**PLANNED UNIT DEVELOPMENT,
PLANNING APPROVAL,
ZONING & SUBDIVISION STAFF REPORT****Date: July 9, 2015**

<u>NAME</u>	Historic Restoration Society, Inc.
<u>SUBDIVISION NAME</u>	Lone Oak Subdivision, Lot 1, Resubdivision of Lot 1/Lot 2
<u>LOCATION</u>	901, 903, & 911 Dauphin Street and 2, 6, 10, & 14 South Broad Street (Southwest corner of Dauphin Street and South Broad Street, extending to the North side of Conti Street)
<u>CITY COUNCIL DISTRICT</u>	District 2
<u>PRESENT ZONING</u>	<i>R-3, Multiple- Family Residential District, B-1, Buffer Business District, and B-4, General Business District</i>
<u>PROPOSED ZONING</u>	B-2, Neighborhood Business District and B-4, General Business District
<u>AREA OF PROPERTY</u>	2 lots / 4.5 acres \pm
<u>CONTEMPLATED USE</u>	Subdivision approval to create two legal lots, Planned Unit Development Approval to allow multiple buildings on a single building site and shared access and parking between two building sites, Planning Approval to allow a float barn in a B-4, General Business District, and <i>Rezoning from R-3, Multiple- Family Residential District, B-1, Buffer Business District, and B-4, General Business District, to B-4, General Business Dist

SITE PLAN

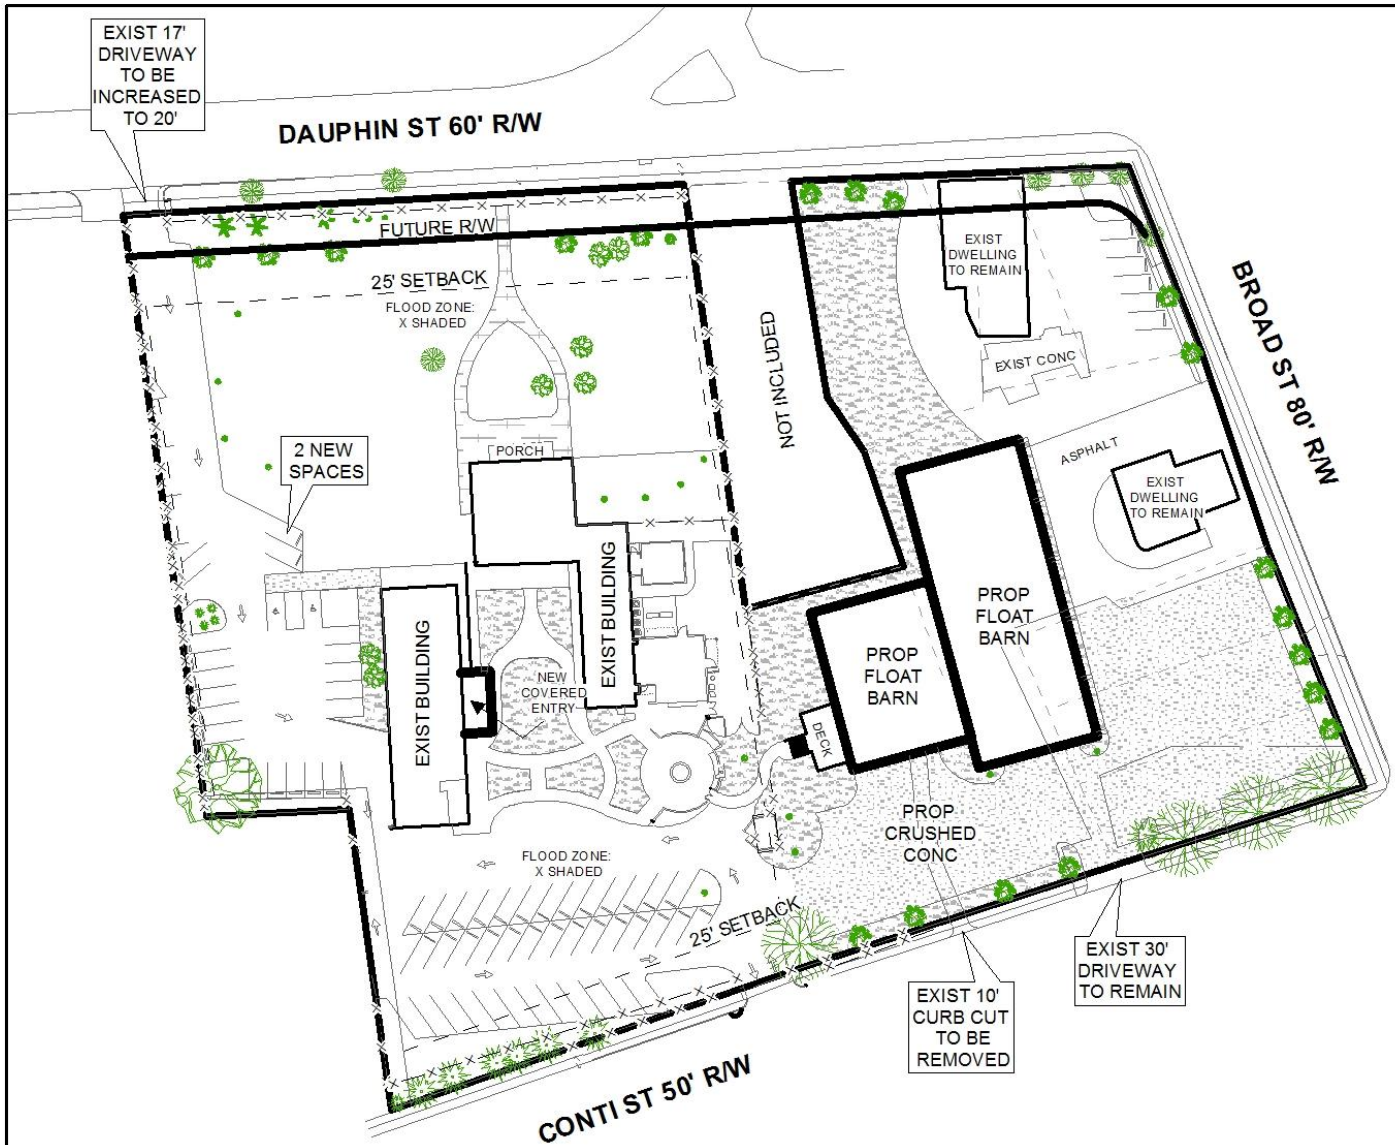
The revised plan shows that numerous existing curb-cuts will be removed on proposed Lot 2, leaving two curb-cuts onto Dauphin Street, one onto Broad Street, and one onto Conti Street. A right-in only curb-cut for Lot 2 on Dauphin Street will be gated, and the curb-cut on Conti Street will also be gated: the gates are proposed to be setback between 20 to 30 feet from the respective rights-of-way. The six-foot high ornamental fence depicted around most of the outside perimeter of Lot 2 appears to break at the proposed curb-cut onto Broad Street, thus it appears that this access point will not be gated. There is nothing on the plan to indicate that the two access points for Lot 1 will have any gates, however, the ornamental fence will be placed along Lot 1's frontage along Dauphin Street, stopping before the curb-cut.

Staff has concerns regarding the tree and landscape aspects of the plan. The site plan shows three existing live oaks at the Conti/Broad Street intersection as being on private property when it actually appears that the trees are between the sidewalk and the curb, within the public right-of-way on Conti Street. Also, given the existing number of live oak trees on or adjacent to the property, the proposed tree planting depicted on the site plan may result in an overplanting and overcrowding situation, as most of the proposed over story trees will have to be live oak trees due to overhead power lines. Staff suggests that the Planning Commission allow the applicant to coordinate tree plantings with staff, with the understanding that some tree banking may be required.

The site plan depicts a 6-foot high wooden privacy fence where the site abuts R-1 property on the Western side of the site. This fence should be provided prior to use of the site.

The applicant has explained the request for crushed concrete surfacing in the float parking and maneuvering area, and crushed rock in the service yard area. A paved apron should be provided at any curb-cut entering into the alternate surfacing area if required by Engineering and Traffic Engineering, to be coordinated with Engineering and Traffic Engineering. Additionally, the crushed rock and crushed concrete areas should have barriers such as bumper stops to prevent vehicles from encroaching into landscape areas or into the adjacent right-of-way. Bumper stops should also be required for those paved parking spaces abutting landscape areas or near property lines.

- 1) *Curb-cuts limited to the revised site plan, with all unused curb-cuts to be removed prior to a certificate of occupancy for the proposed float barns;*

- 2) *Revision of the site plan to depict any paved curb-cut aprons leading to the crushed rock or concrete surfaces, to be coordinated with Engineering and Traffic Engineering if such aprons are required;*

- 3) *Revision of the site plan to show the three existing live oak trees on Conti Street at Broad Street as being within the public right-of-way, between the sidewalk and the curb, rather than on Lot 2;*

- 5) *Provision of a six-foot high wooden privacy fence along the Western boundary of the property where it abuts R-1 properties prior to the use of the site;*

- 6) *Revision of the site plan to show bumper stops for paved parking areas abutting property lines or landscape areas;*
- 7) *Revision of the site plan to show bumper stops or similar barriers around the crushed rock and crushed concrete areas to prevent vehicles from encroaching into landscape areas or across property lines;*
